**BELL BEND NUCLEAR POWER PLANT  
JOINT PERMIT APPLICATION: PPL RESPONSE TO  
ADMINISTRATIVE INCOMPLETENESS NOTIFICATION  
BNP-2011-210 Docket No. 52-039**

References: 1) J. Dresch, PADEP, to T. L. Harpster, "Acknowledgement  
Letter/Administrative Incompleteness Notification, DEP Application  
No. E40-720", October 25, 2011

Administrative Incompleteness Notification  
DEP Application No. E40-720  
APS No. 753143  
Bell Bend Nuclear Power Plant  
Salem Township, Luzerne County

SHEET TITLE:  
**ENCLOSURE D2 - BBNPP WETLAND & WATERCOURSE IMPACT LOCATION MAP - DEP**  
Bell Bend Nuclear Power Plant  
Luzerne County, PA

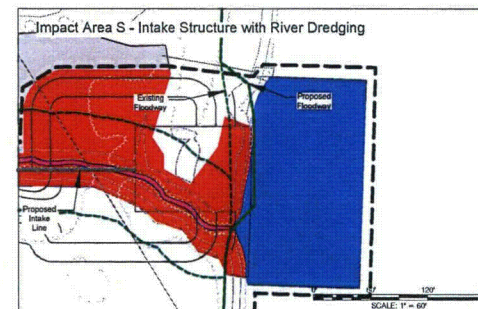
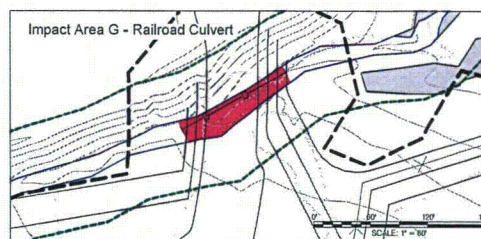
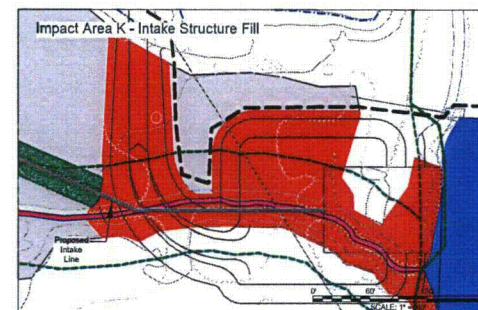
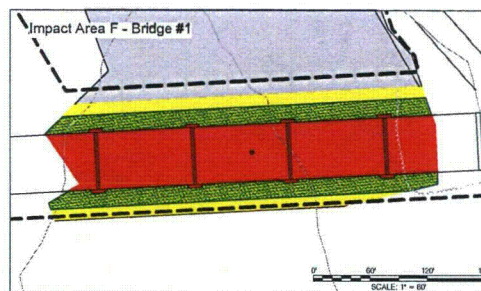
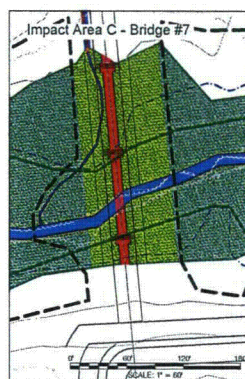
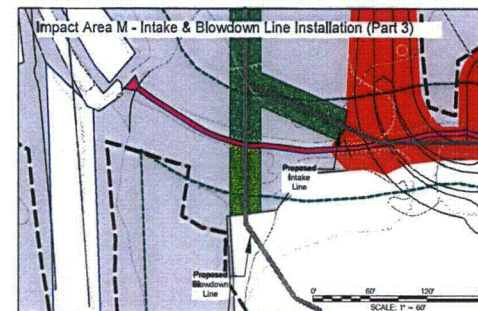
1. Please more clearly define which wetland areas are “to be created” and which wetland areas are existing natural features. This comment is applicable to Impacts: B,C,D,E, I, J, K, M, P, Q, and R.

2. Please provide a delineation of the 100-year floodway and the 100-year floodplain associated with all watercourses impacted by the project. If a FEMA Flood Insurance Rate Map depicting the limits of the 100-year floodway and/or the 100-year floodplain is not available, then the 100-year floodway is assumed to extend 50’ laterally from the point at which the normal water elevation within the stream channel meets the stream’s bank. This comment is applicable to watercourses altered as a result of Impacts: A, B, C, D, E, E, G, H, N, O, U, and V.

**Response:** No wetland creation is proposed in conjunction with any impacts with letter identifiers. All Wetland impacts are depicted in detail on the Impacts Map (Enclosure D2, Section R, Binder 1B). Wetland mitigation areas are shown as a hatched area on the JPA Plans. More detailed information regarding creation and enhancement areas are provided in Section R (Binder 1C) in the mitigation design reports and plans.

**Response:** The floodway has been added to the Impacts Map (Enclosure D2, Section R, Binder 1B). Enlargements have been added to this plan to depict all impacts affecting the regulatory floodway.

SCALE AS NOTED	DRAWING NO.  <b>B2-S2</b>
DRAWN BY ASA	
DATE 1-28-11	
APPROVED 4-19-11

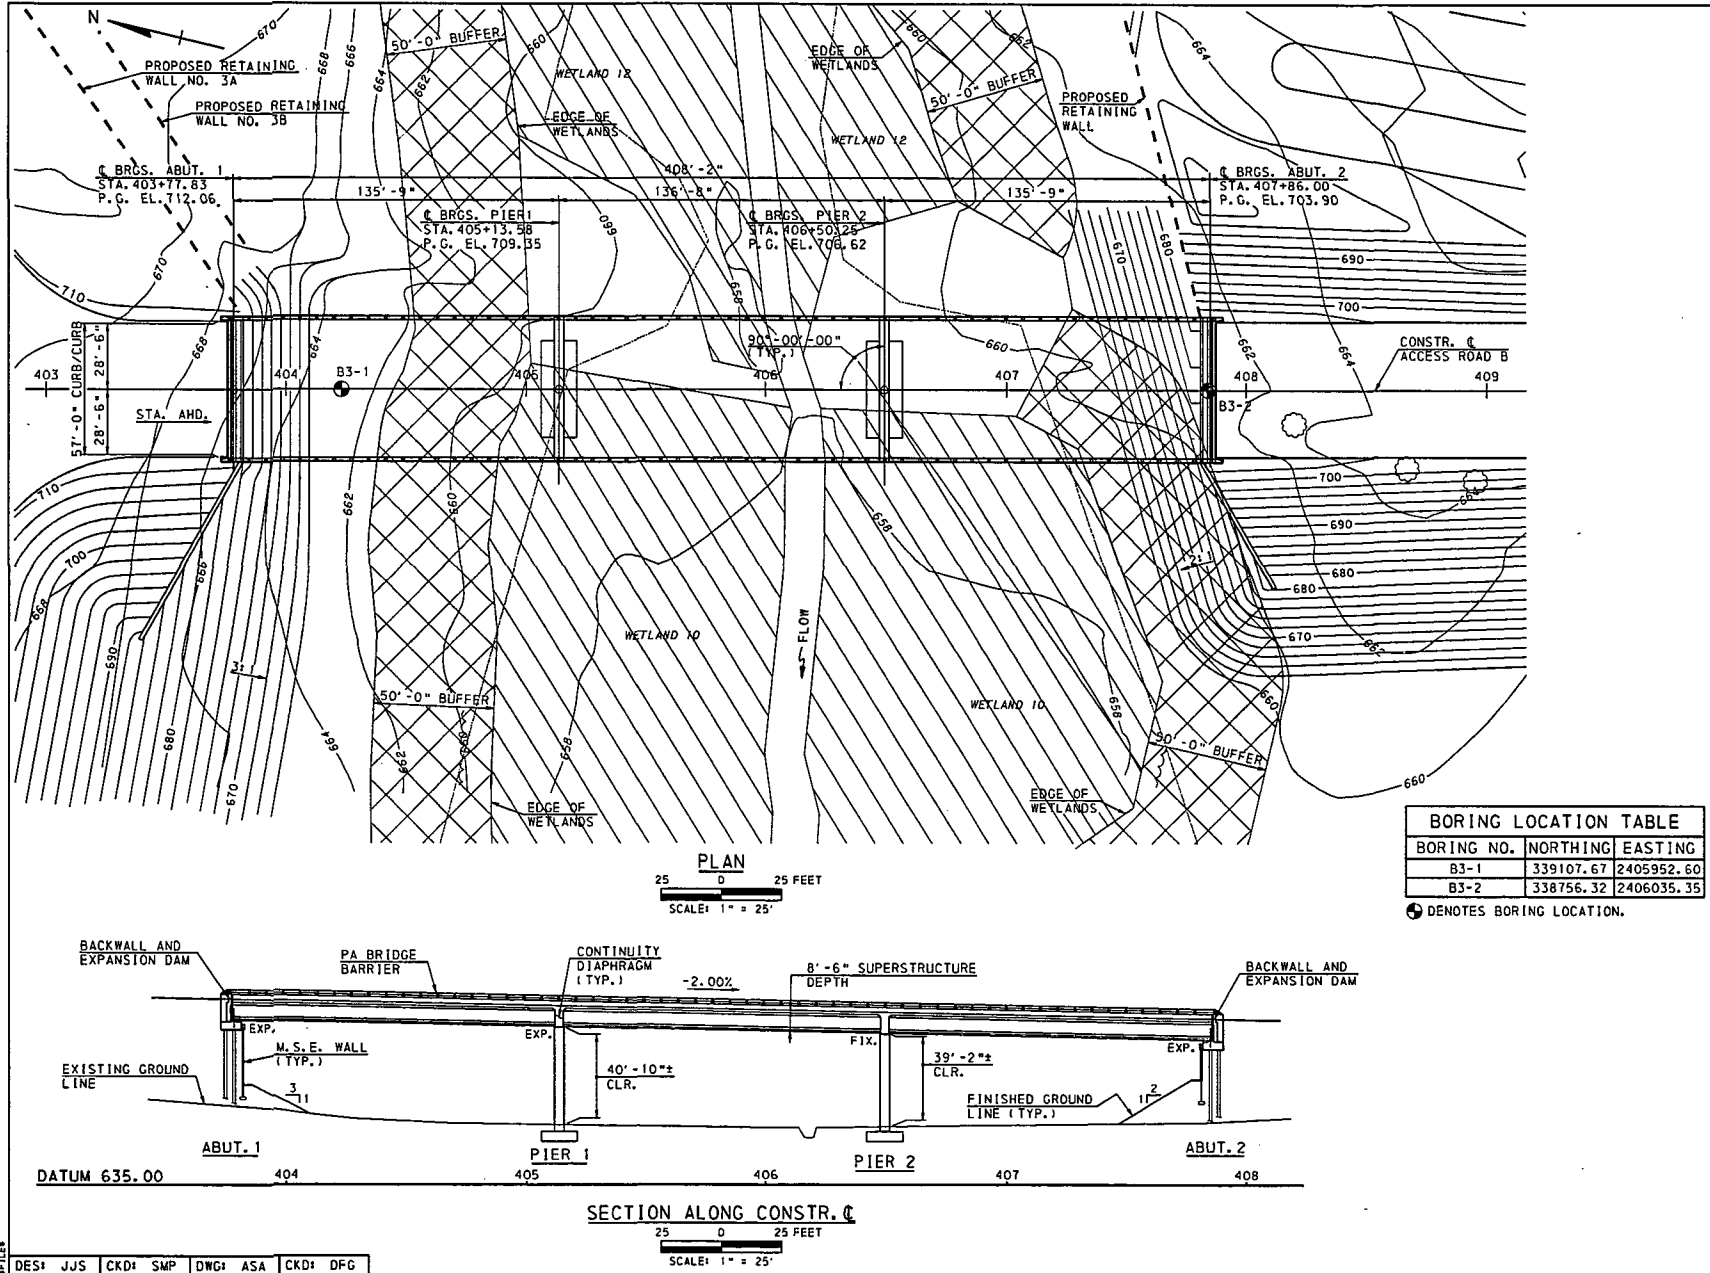
3. Please provide a “utility detail map” on sheet “B2-S2” for Bridge #6.

**Response:** A Utility Detail Table has been added to Sheet B2-S2 of the Bridge Drawings.

TYPE	MATERIAL	DIAMETER	QUANTITY
ELECTRICAL	GALV. RIGID STEEL	6"	20
CIRC. WATER	CARBON STEEL	32"	1
BLOW DOWN WATER	HDPE	26"	1
WATER	CARBON STEEL	20"	1

SCALE  
 1" = 25'  
 DRAWN BY  
 ASA  
 DATE  
 1-28-11  
 APPROVED  
 4-18-11  
**B3-S1**

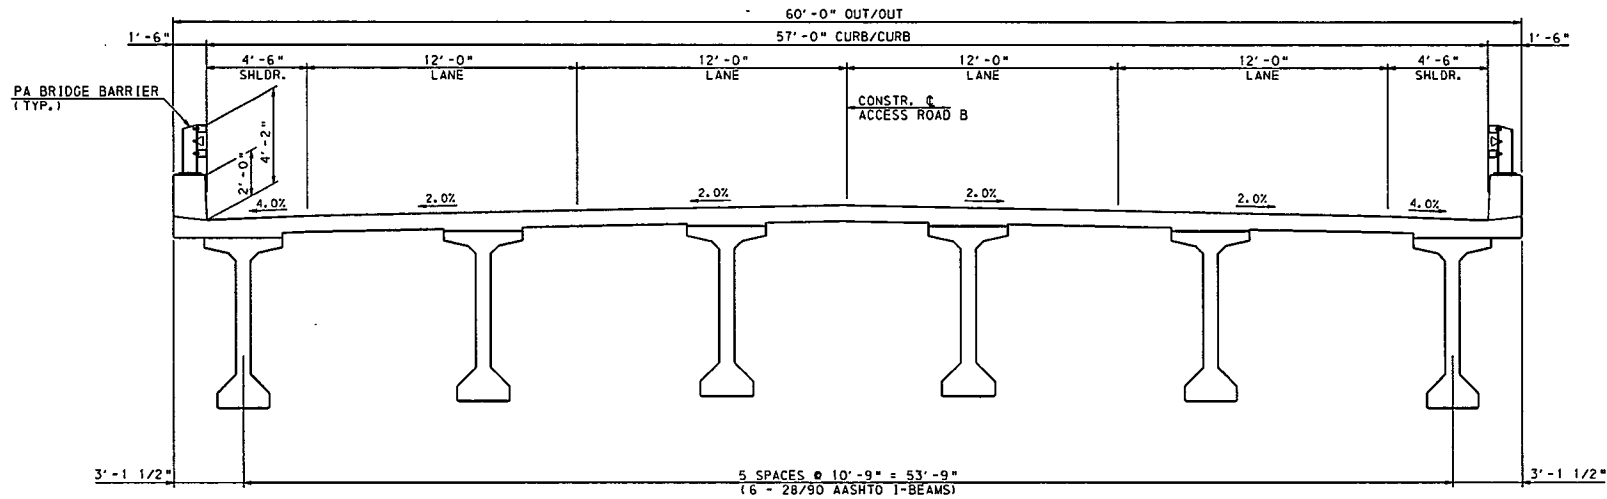
4. Please note that “Wetland #10” on sheet “B3-S1” should be labeled as “Wetland #12.” This comment is applicable to “Impact B.”

**Response:** The existing wetland boundary and wetland labels have been corrected on Sheet B3-S1 of the Bridge Drawings.

DATE: 04/15/2011  
BY: JPL  
CHECKED: JPL  
APPROVED: JPL  
SCALE: 1" = 10' (Horizontal), 1" = 10' (Vertical)  
SHEET: 43 OF 44  
PROJECT: CS3205

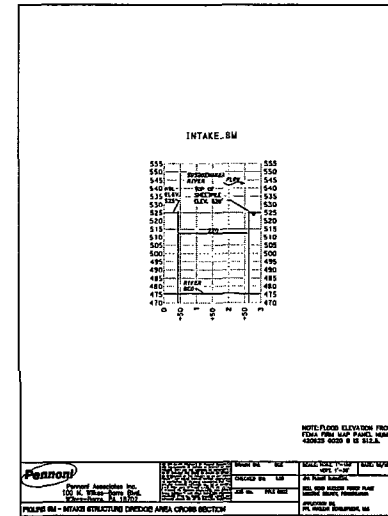
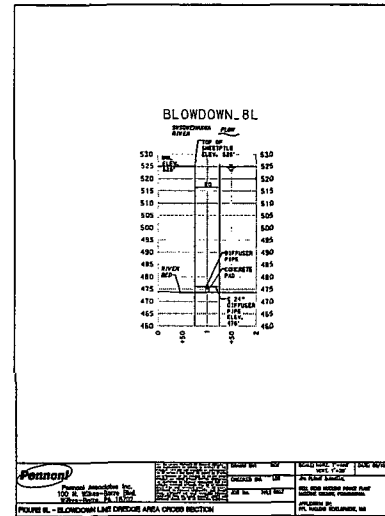
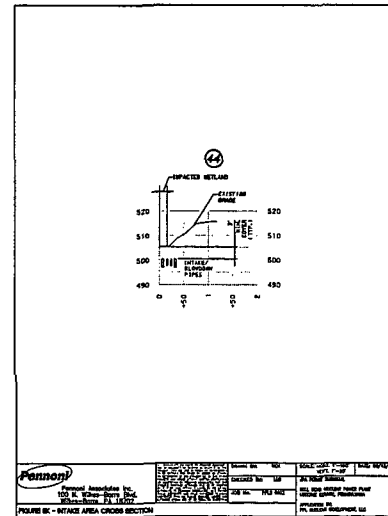
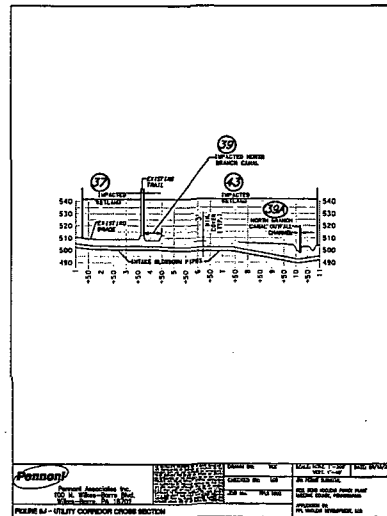
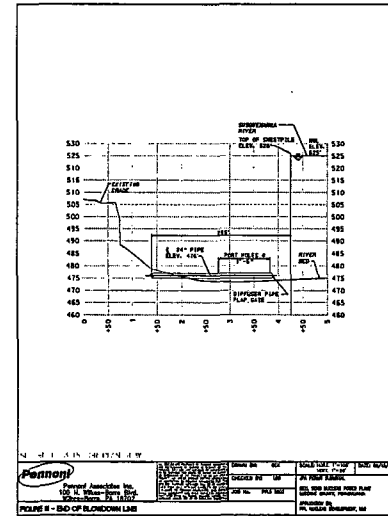
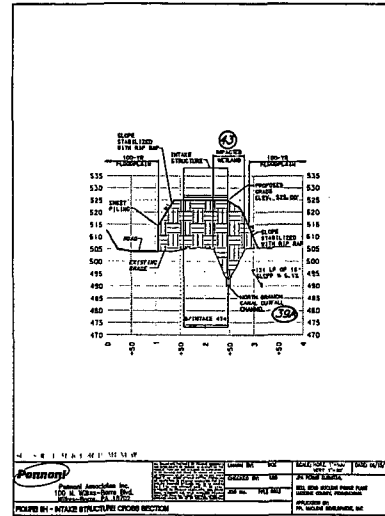
6. Please provide more details on the intake structure (“Impact S”) within the floodway.

**Response:** The existing and proposed floodway have been added to Figure 8F on Sheet CS3205 of the JPA Plans (Binder 1A). This figure shows a cross section of the intake structure area, including the existing river bank.

CS3206

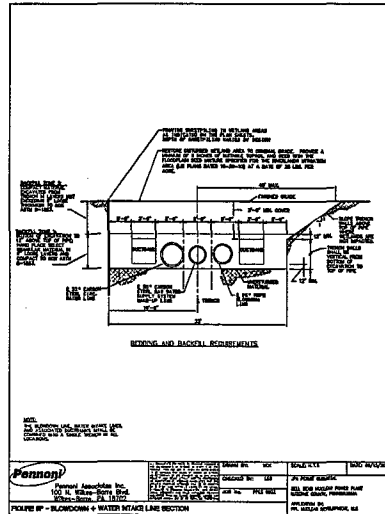
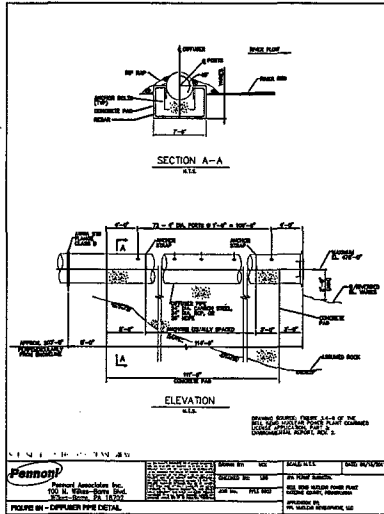
5. Please provide the size and material type utilized for the water intake and blowdown pipeline associated with “Impact M.”

**Response:** The sizes and materials of the intake and blowdown lines have not yet been finalized. However, likely sizes and materials have been noted on Figure 8P on sheet CS3206 of the JPA Plans (Binder 1A), with a note that these are subject to final design. Text descriptions have also been added to Section H, Project Narrative (Binder 1) and Section J, Environmental Assessment, Enclosure D (Binder 1B).
